ADDENDUM NO. 1

TERRY CARGIL RESERVOIR

LACEY CONTRACT NO. PW 2019-32

SHEET
M-3
34 of 62

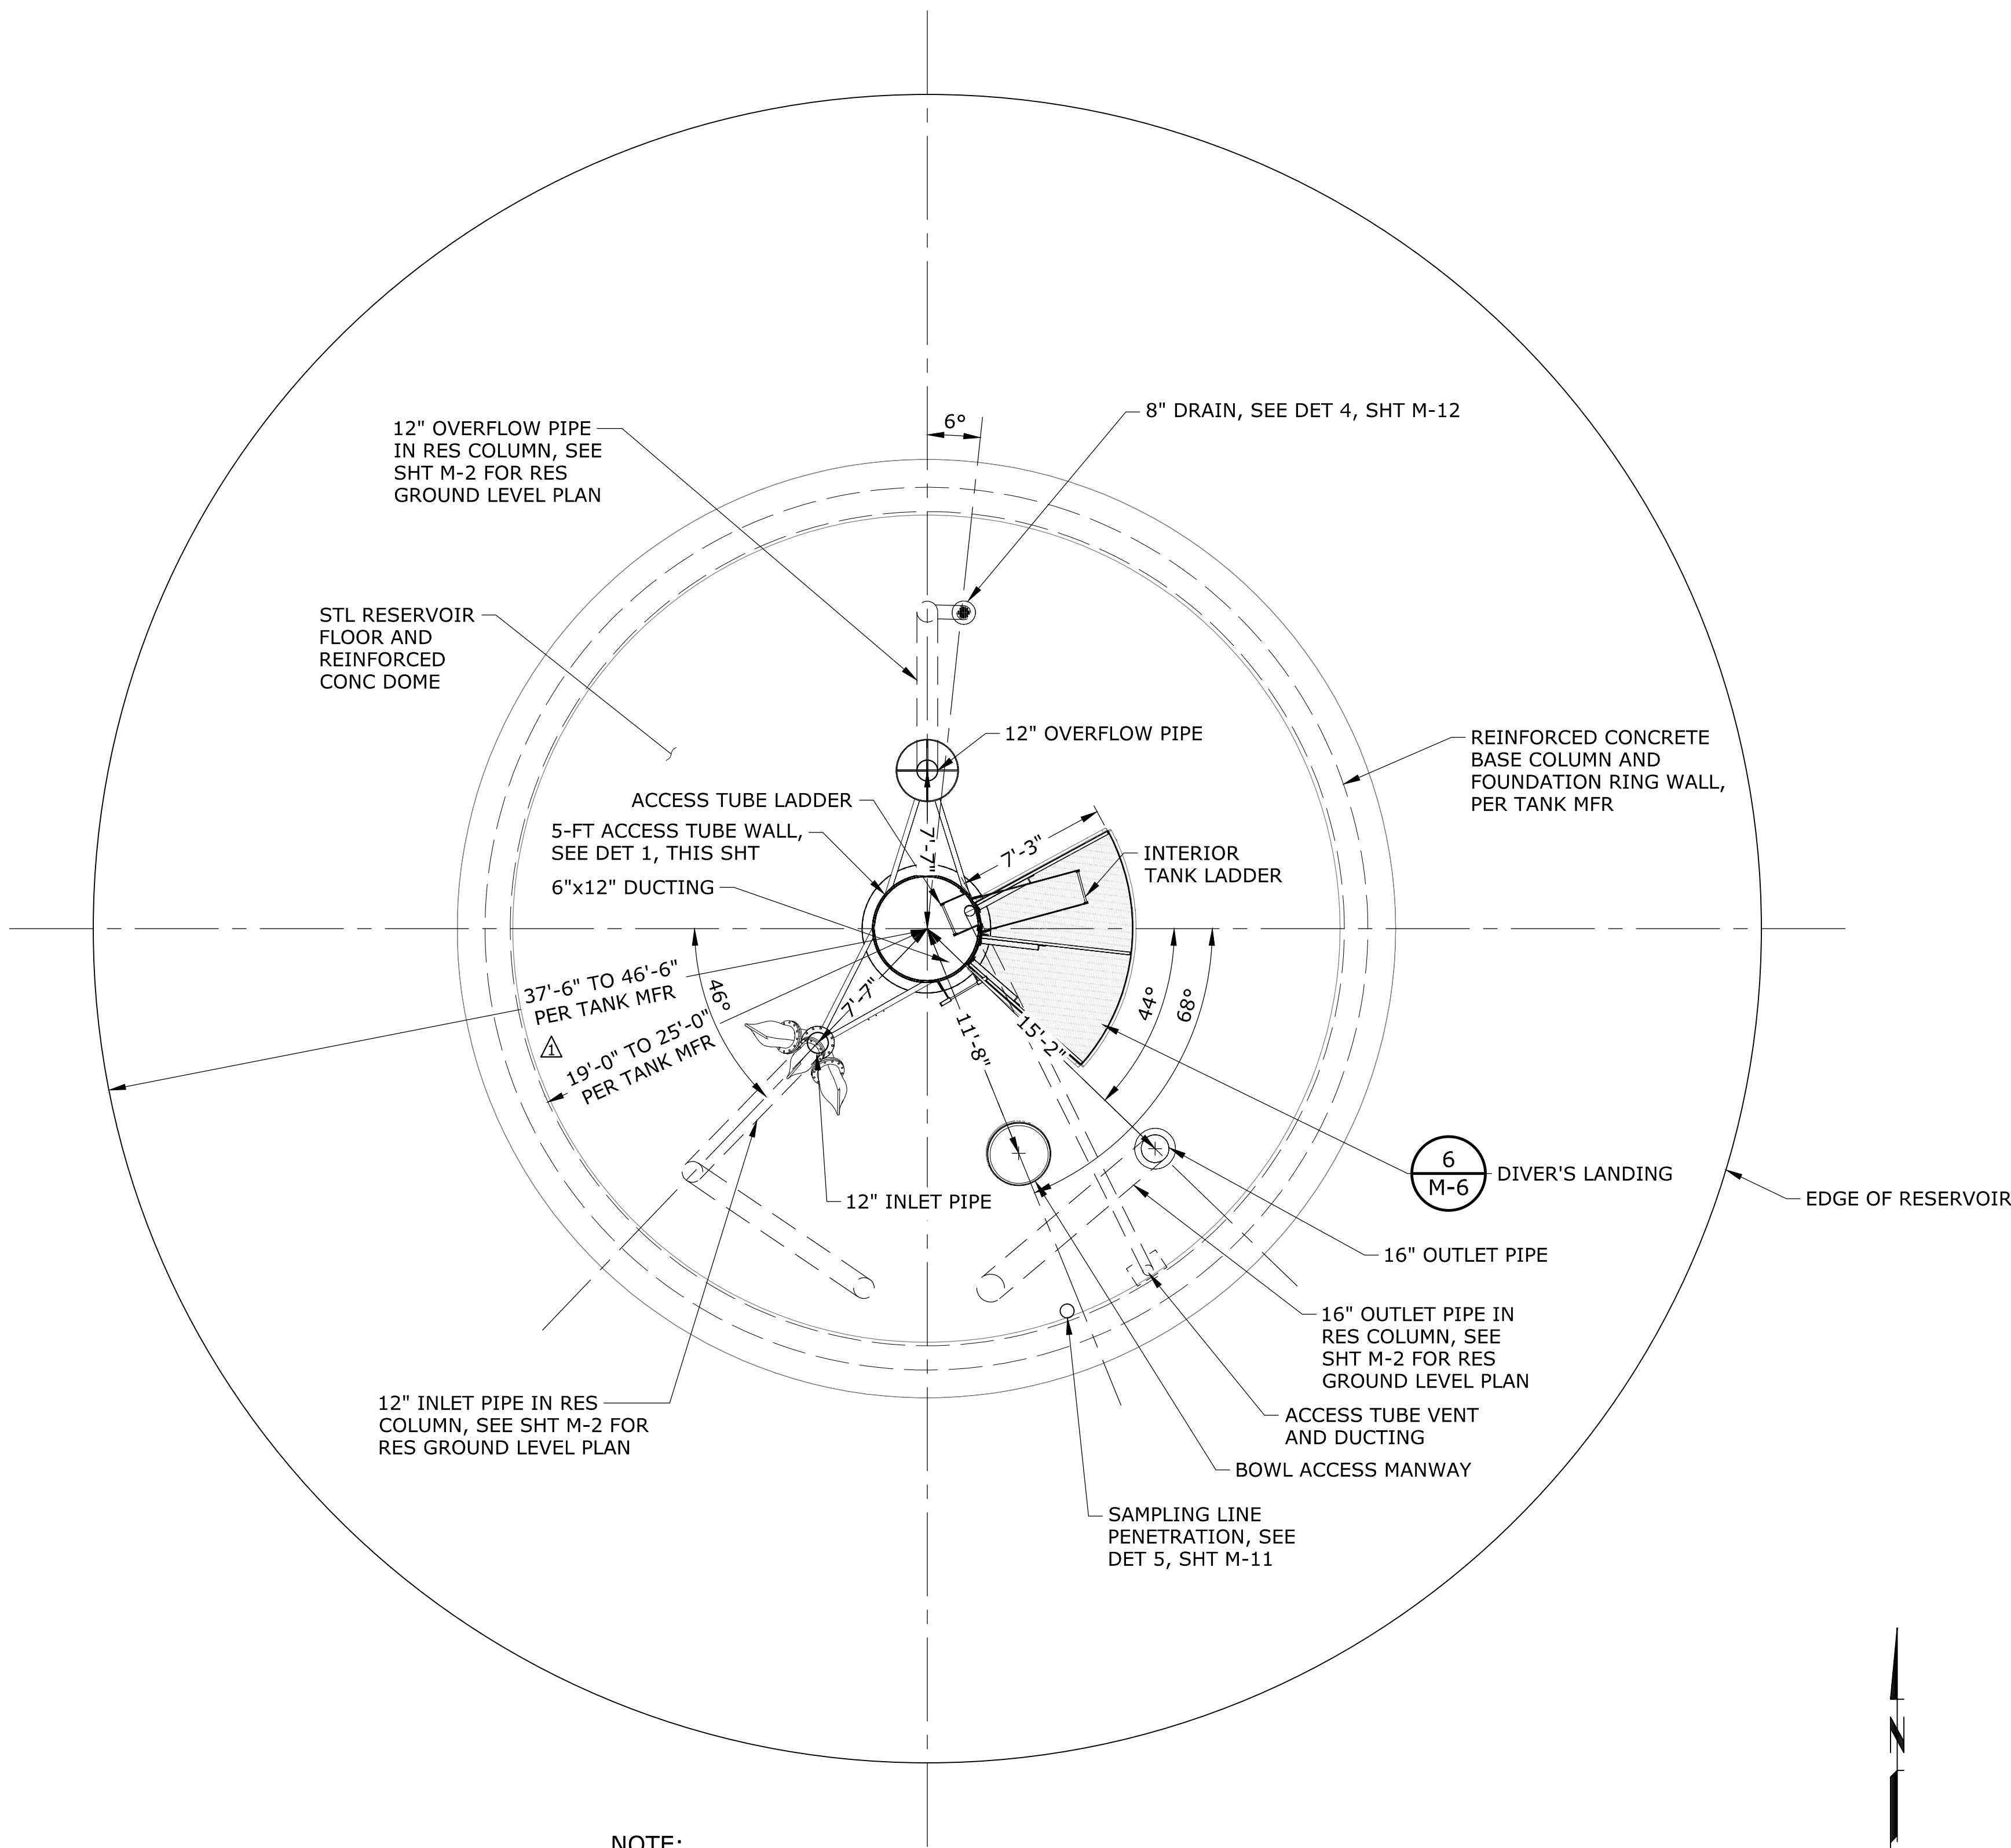
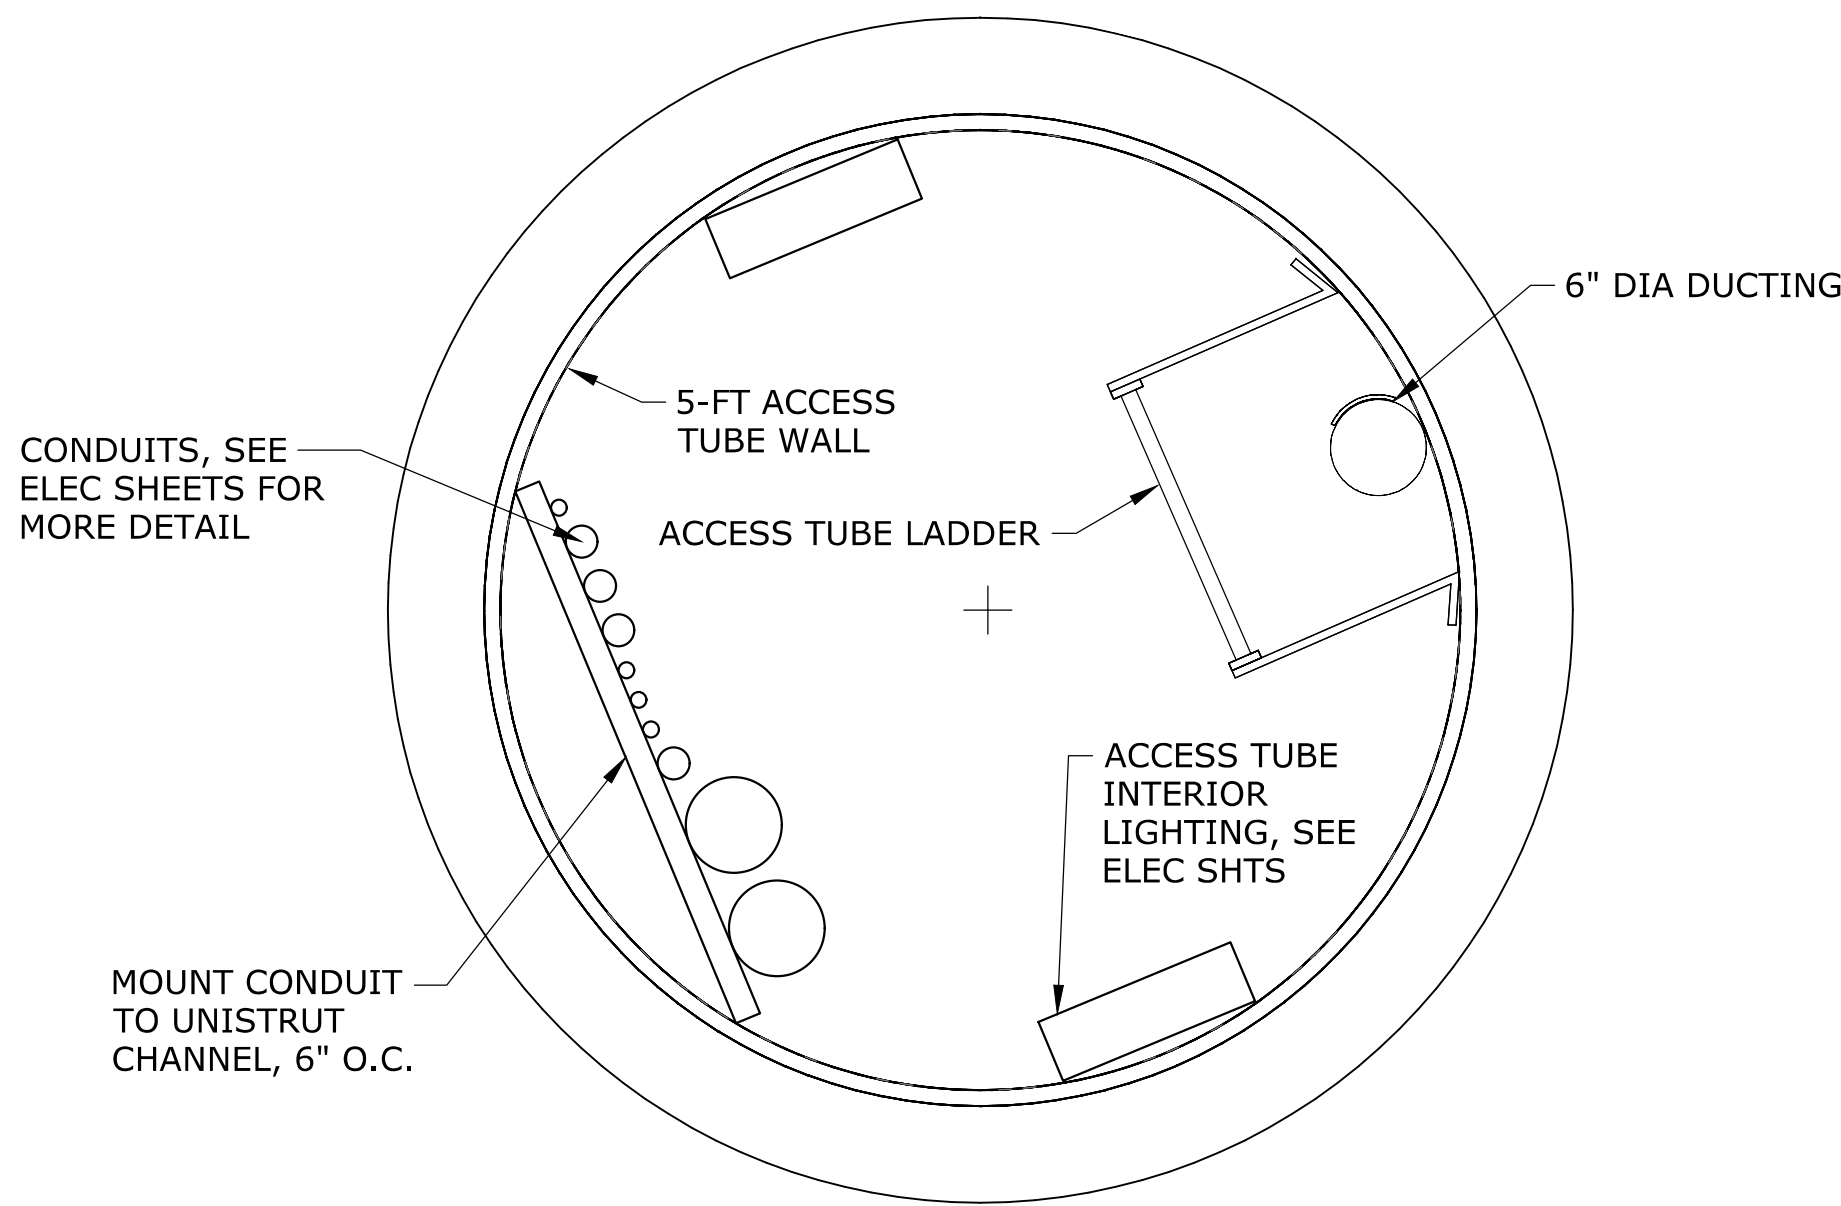
- 1) *The revisions include changes to notes related to the reservoir radii.*
Delete Sheet M-3 / Page 34 of 62 and replace it with the new page as attached.

RESERVOIR ROOF PLAN

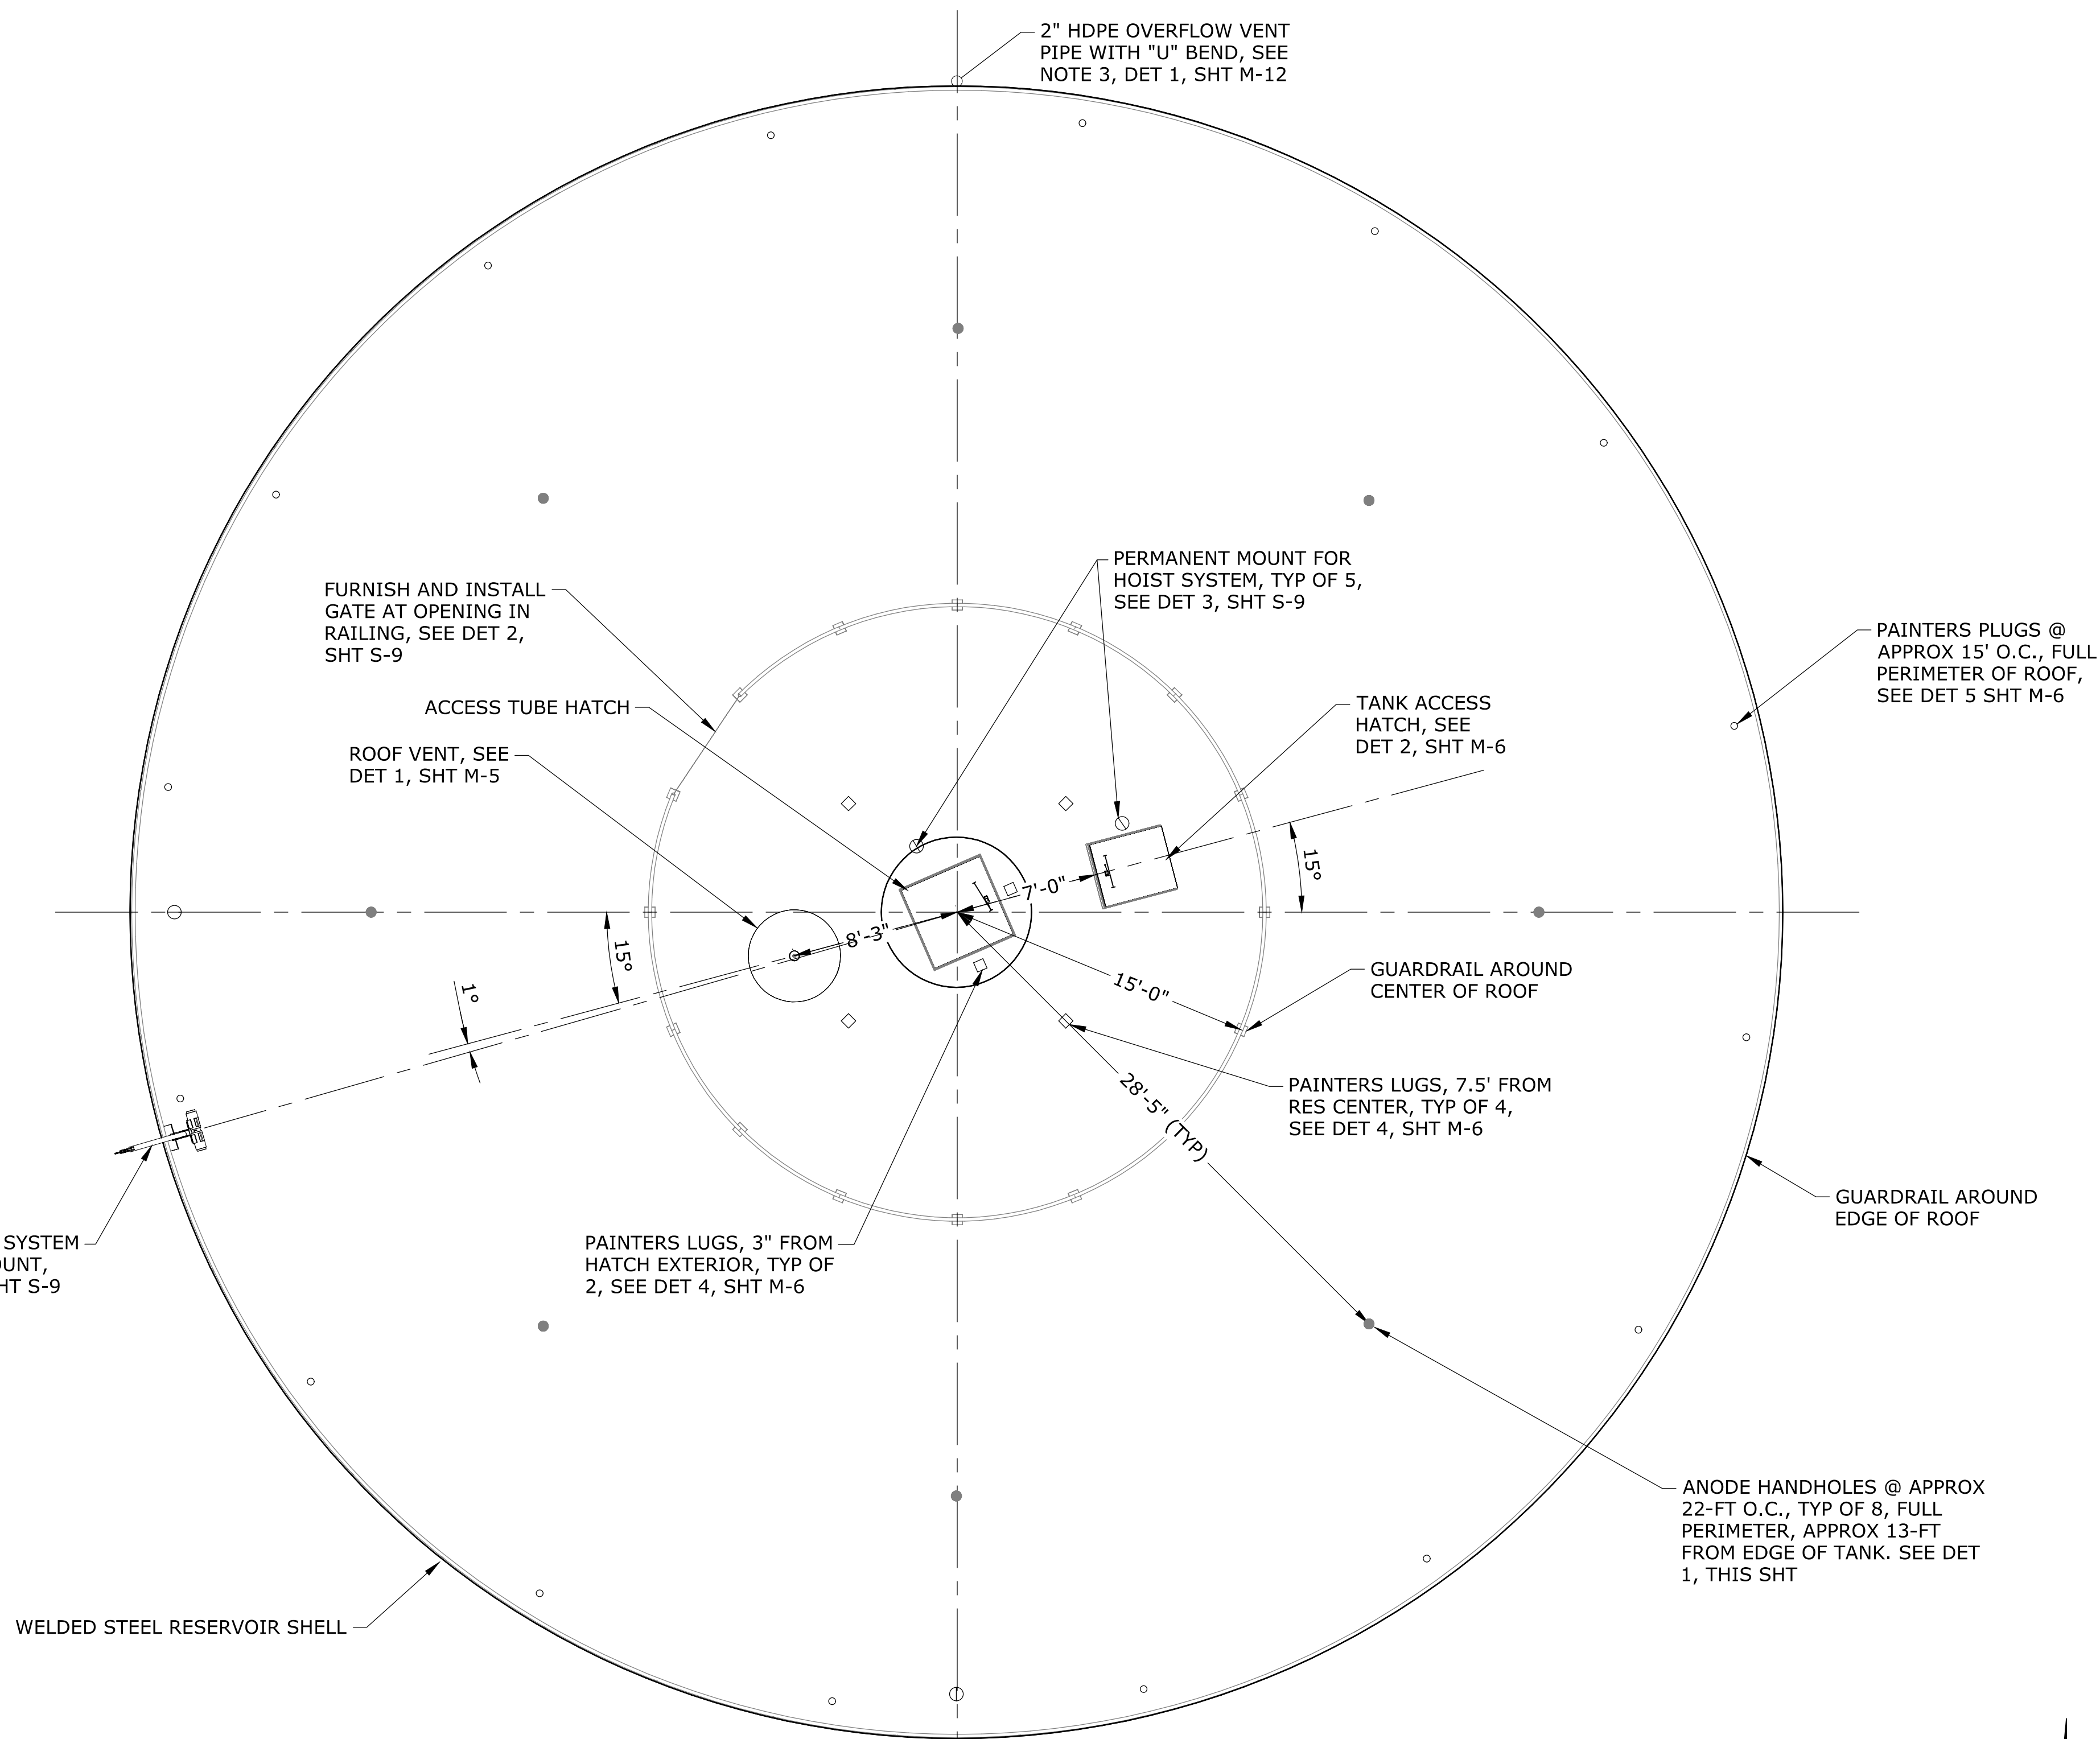
- 1) *The revisions include changes to notes related to the hatch and vent spacing.*
Delete Sheet M-4 / Page 35 of 62 and replace it with the new page as attached.

1. FOR GUARDRAILS, SEE SHEET S-9.
2. SPACING BETWEEN ACCESS TUBE HATCH, TANK ACCESS HATCH, AND ROOF VENT MAY BE ADJUSTED TO ACCOMMODATE RESERVOIR STRUCTURAL DESIGN, PROVIDED SAFE ENTRY AND EGRESS PATHS FROM HATCHES ARE MAINTAINED. HATCHES AND VENT SHALL REMAIN WITHIN INTERIOR GUARDRAIL AROUND CENTER OF ROOF.
